Re: Indian Point Unit No. 2  
Docket No. 50-247

Fire Protection  
Appendix R  
Clarification Request

Consolidated Edison Company of New York, Inc.  
Indian Point Unit No. 2  
Docket No. 50-247  
April 1984

## Fire Protection (Appendix R) Clarification Request

4" FIRESTOP/SMOKE SEAL  
-Typical-

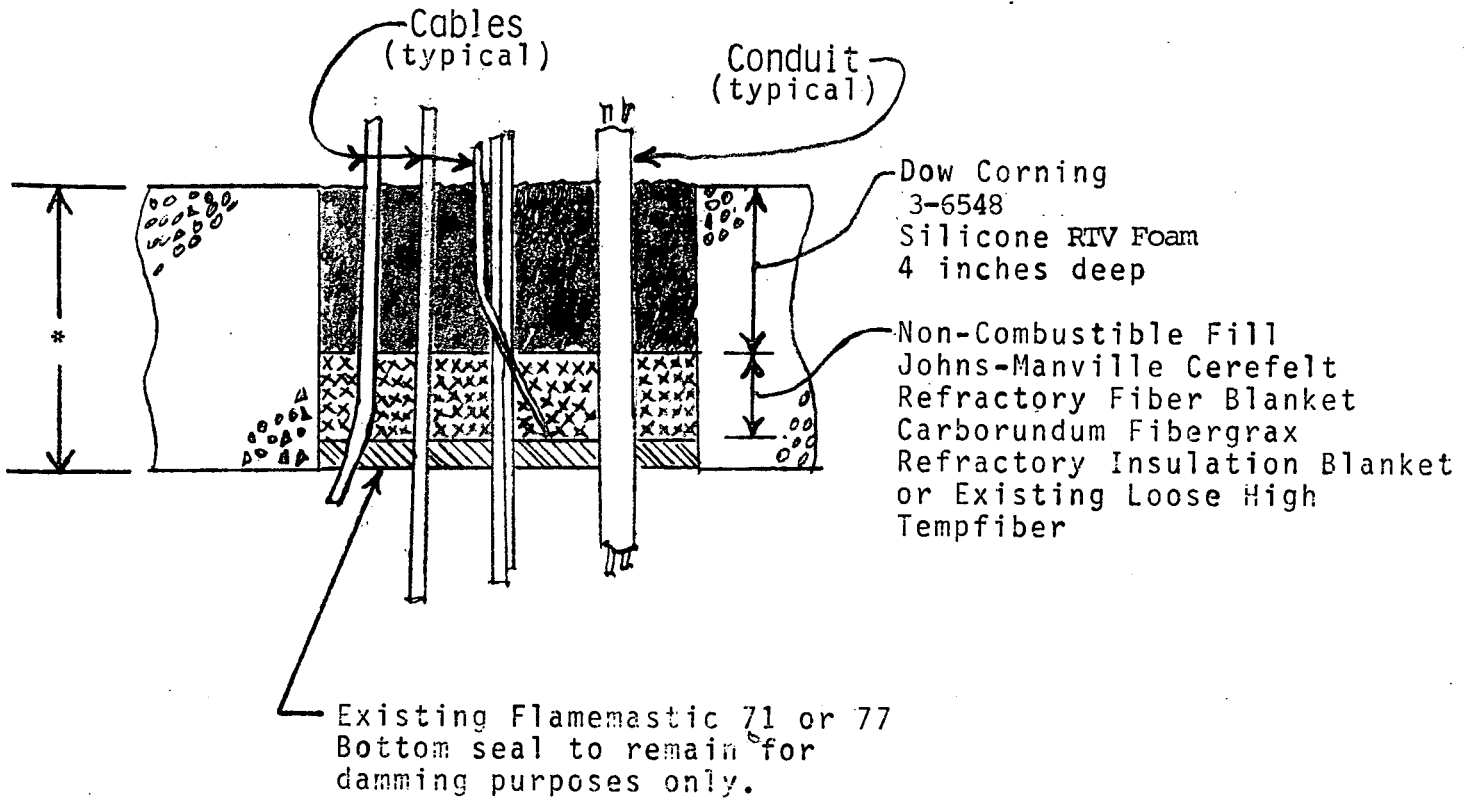
The NRC was advised that previous Con Edison commitments require certain fire barriers (Types II and III identified in the September 9, 1983 submittal to the NRC) to have functional penetration seals to act as smoke seals. Con Edison proposes to partially remove existing Flamemastic and Fiberglass seals in need of repair and install four-inch thick Dow Corning (DC-3-6548) silicone RTV foam seals.

The lower portion of the existing Flamemastic and Fiberglass floor seals may be used as a dam but this material will not be considered as part of the smoke seal. Where no Flamemastic material is present in the penetration, an alumina silica fiber blanket or board (Cerafelt, Cera board, etc.) dam will be installed and four inches of DC-3-6548 silicone RTV foam will be placed to form the smoke seal. Where it is impractical to remove the existing Flamemastic seals to a depth of four inches, a four-inch high collar will be placed around the penetration and an above the floor silicone RTV foam seal will be installed. The attached sketches, (SK FP-001, SK FP-002) show typical floor smoke seal designs proposed for Indian Point Unit No. 2. Wall penetration seals shall have no damming left in place.

Con Edison will prepare a procedure to inspect these seals on an 18-month basis to insure their integrity.

**4" FIRESTOP/SMOKESEAL - TYPICAL**  
**\*\*COVERING EXISTING SEAL**

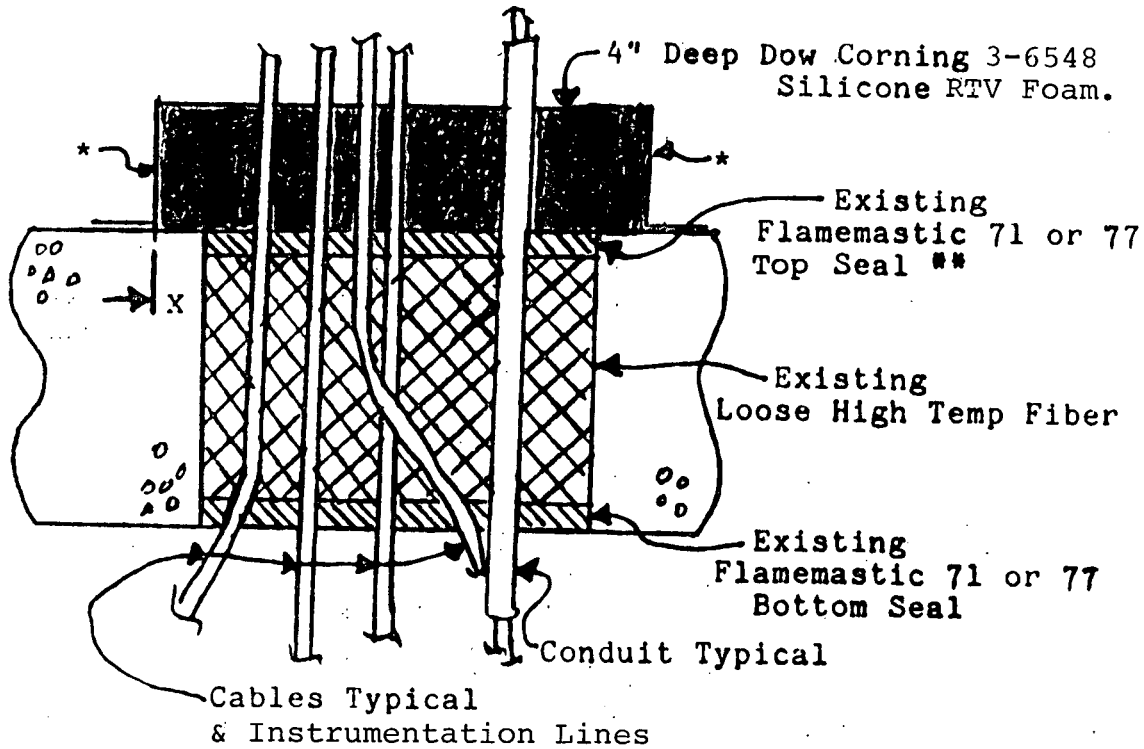
\*\*Where it is impractical to remove the existing Flamemastic seal to a depth of four inches, a four inch high collar will be placed around the penetration and an above the floor silicone foam seal will be installed as shown.

\*Forming collar shall be 4" high 24 gauge galvanized steel, secured to substrate with 1/4" bead of Dow Corning 96-081 high temperature silicone adhesive.

Collars are only required where the seal may be subject to mechanical abuse. (i.e., walkways, etc.)

Where collars are not required (i.e., inside control cabinet) seals can be formed with approved damming boards. After the seal is poured, the damming boards may be removed and the silicone foam seal shall be bonded, if necessary, to its substrate, with Dow Corning 96-081 high temperature silicone adhesive sealant.
